STATE OF WASHINGTON  
 DEPARTMENT OF HEALTH  
 SOUTHWEST DRINKING WATER REGIONAL OPERATIONS  
 P.O. Box 47823 Olympia, Washington 98504-7823  
 TDD Relay 1-800-833-6388

April 12, 2016  Dell Hilger 1121 Westside Highway Kelso, Washington 98626	<b>Beacon Hill Water and Sewer District          ID #15650D</b>	
	County:	Cowlitz
	System Type:	Group A Community
	Operating Permit Color:	Green
	Surveyor:	Teresa Walker
	Inspection Date:	March 30, 2016

**Ostrander reservoir hatches**

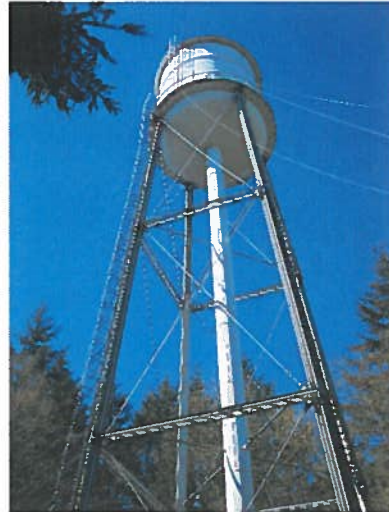
Ostrander does not have a gasketed hatch, as it is a manhole cover to an at-grade reservoir. **Please provide a watertight seal for this cover.** Ostrander and Skyline are below grade reservoirs and have at grade vents which are screened. Beacon Hill is an elevated steel tank supported by a steel truss. Beacon Hill will have a structural inspection performed next month. The vent for Beacon Hill does not have a screen. **Please modify the vent opening and install screens for Beacon Hill reservoir. Please confirm that the Beacon Hill tank support structure is structurally sound, following the inspection.**

1. **Please provide a watertight seal for the Ostrander reservoir cover.**
2. **Please modify the vent opening and install screens for the Beacon Hill reservoir.**
